Re: Response to submissions received – DA2022/0033 at 30A Addison Road, Manly.

I write on behalf of Mr Shamia (Applicant) in response to the submissions received following Council's notification of Development Application DA2022/0033, which seeks consent for the demolition of the existing dwelling and the construction of a new dwelling at 30A Addison Road, Manly.

Figure 1: Overlay of the Detail & Boundary Survey atop of the Roof Plan

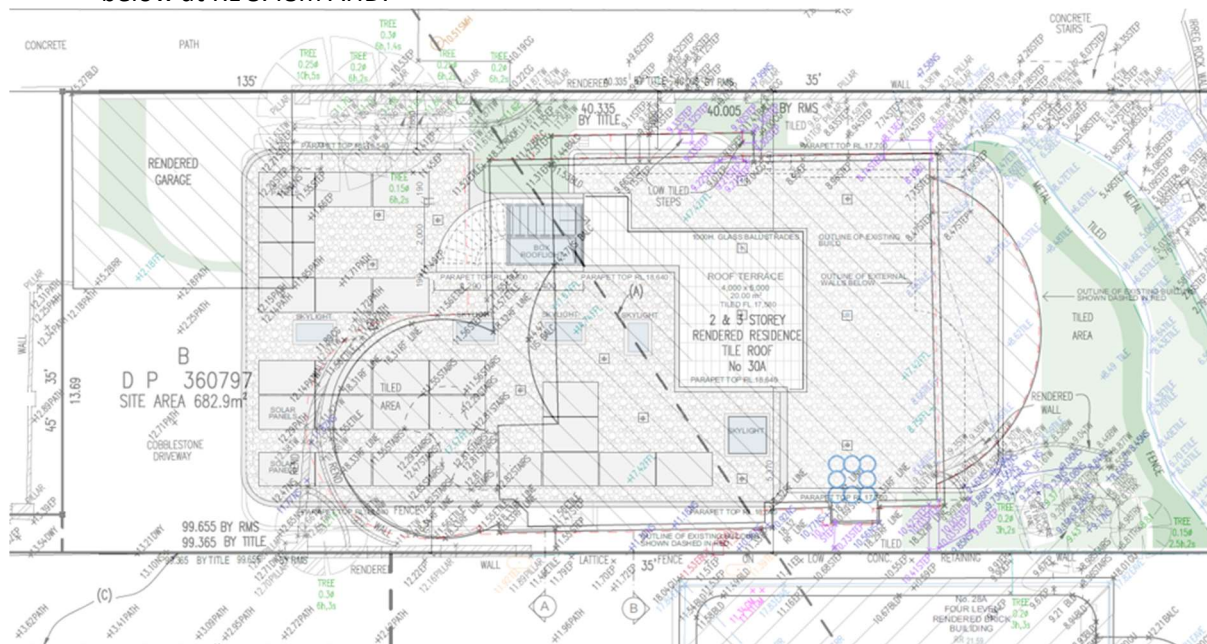
A submission was received from Johns & Bolding of 30 Addison Road which suggests that the maximum building height of 9.2m, as nominated in the SEE and supporting Clause 4.6 Submission, is incorrect. The submission suggests that there are three separate areas of non-compliance, as follows:

- The south-eastern corner of the roof over the upper floor balcony breaches the height plane by 2.6m, to a maximum height of 11.1m,
- The south-eastern corner of the roof terrace parapet breaches the height plane by 1.9m, to a maximum height of 10.4m, and
- The south-eastern corner of the balustrade of the roof terrace breaches the height plane by 1.1m, to a maximum height of 9.6m.

The most precise way of calculating building height where the proposed development extends beyond the footprint of the existing building is to superimpose/overlay the Detail & Boundary Survey atop of the Roof Plan. Upon review of the overlay of the Detail & Boundary Survey atop of the Roof Plan (Figure 1), I confirm that:

- the south-eastern corner of the roof over the upper floor balcony reaches a maximum height of **9.22m**, breaching the height plane by 720mm. This is based on measuring the vertical distance between the south-eastern corner of the roof at RL 17.7m AHD and the land directly below at RL 8.48m AHD.

An amended clause 4.6 request will be submitted to correct the nominated maximum building height from 9.2m to 9.22m.

Figure 2: Interpolated height blanket

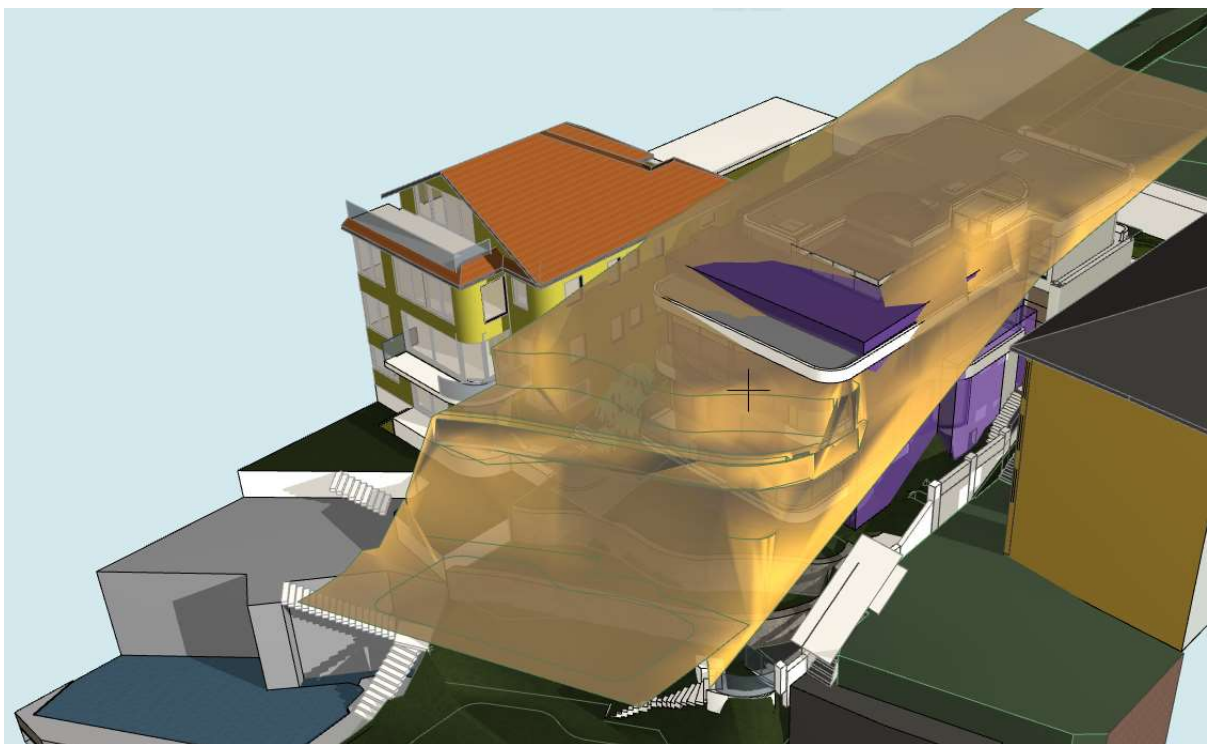
Where the ground levels are unable to be determined (within the footprint of the excavated building), Council allows for extrapolation or interpolation, consistent with the decision of Commission O'Neill in *Bettar v Council of the City of Sydney* [2014] NSWLEC 1070. Upon review of the height blanket prepared to accompany the proposed development (Figure 2), and the Sections that highlight the interpolated ground levels, I confirm that:

- The south-eastern corner of the roof terrace parapet does not exceed the 8.5m height plane, and
- The south-eastern corner of the balustrade of the roof terrace marginally breaches the 8.5m height plane by approximately 200mm.

Figure 3: Amended roof plan

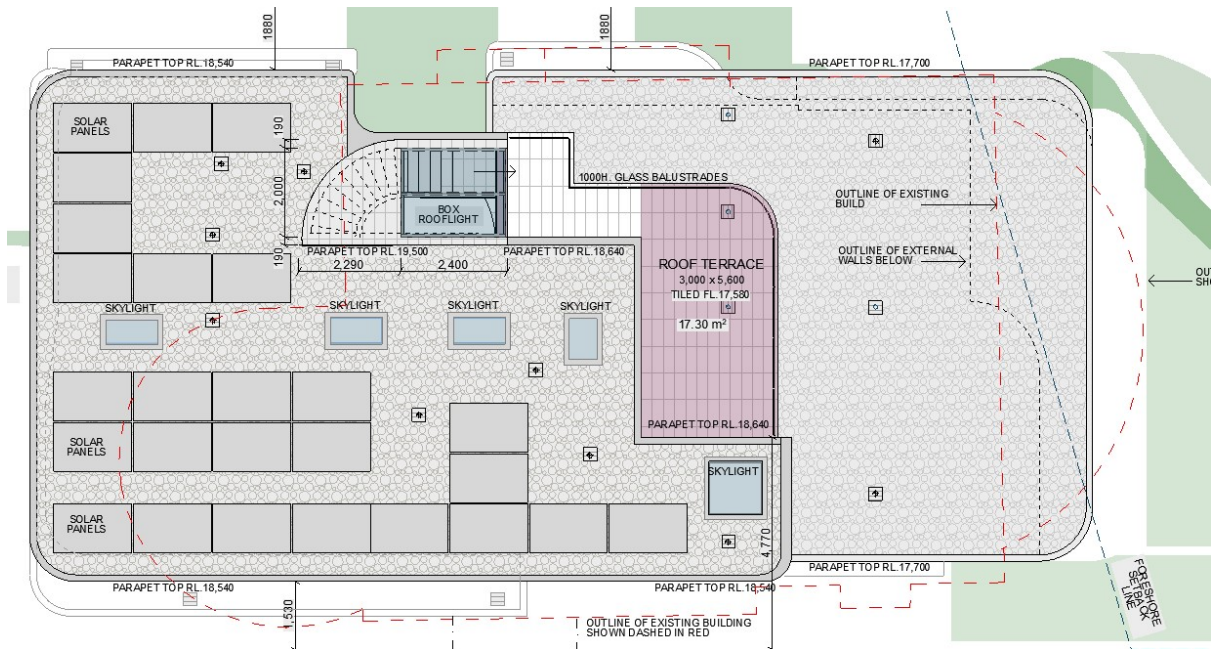
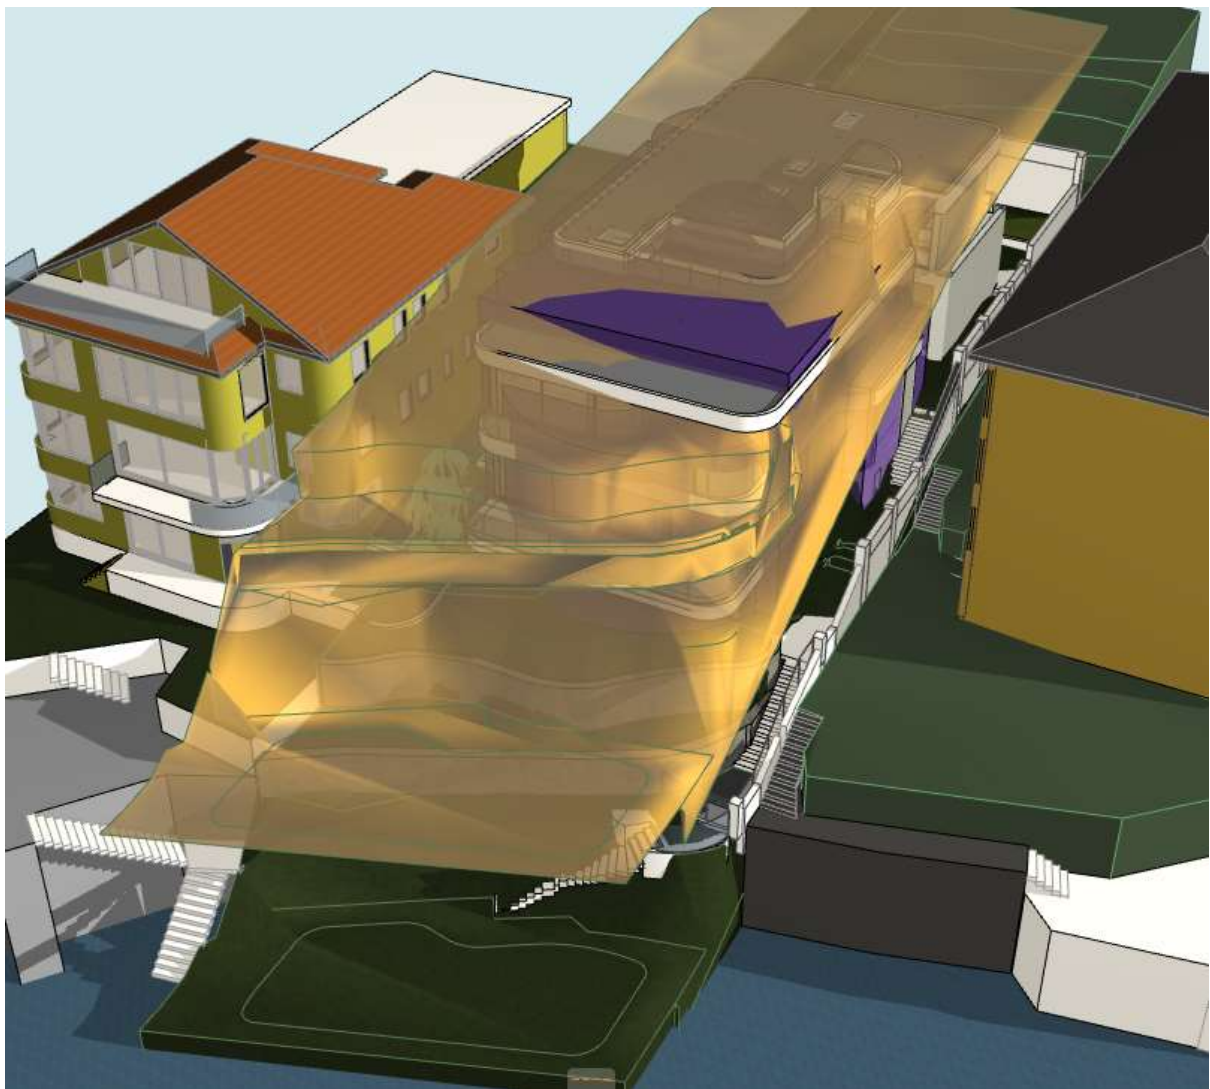
The size/depth of the roof terrace can be reduced to address this unintentional non-compliance. An extract of the amended design is provided in Figure 3 (over page) with the amended height blanket at Figure 4 (over page).

Figure 5: An extract of the South-Eastern Elevation

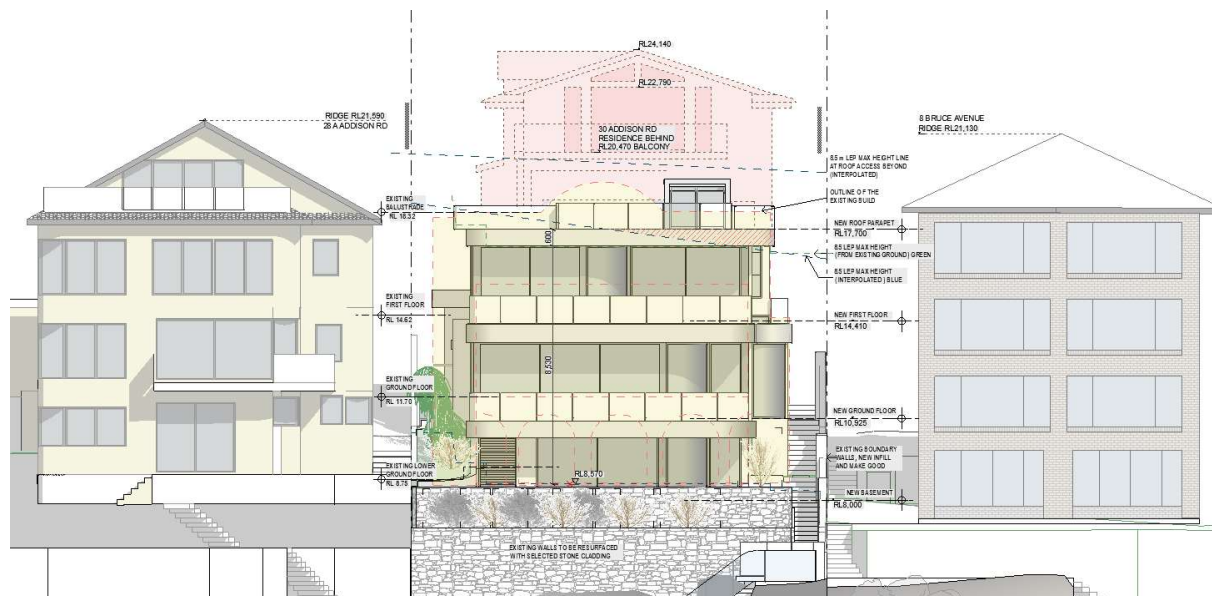
The height non-compliances associated with the proposed development are acknowledged, however these areas are relatively minor components of the development that arise due to the topography of the land and do not detrimentally impact upon the bulk and scale of the development. The majority of the dwelling is maintained below the height plane and remains lower than adjacent roof forms (as seen in Figure 5).
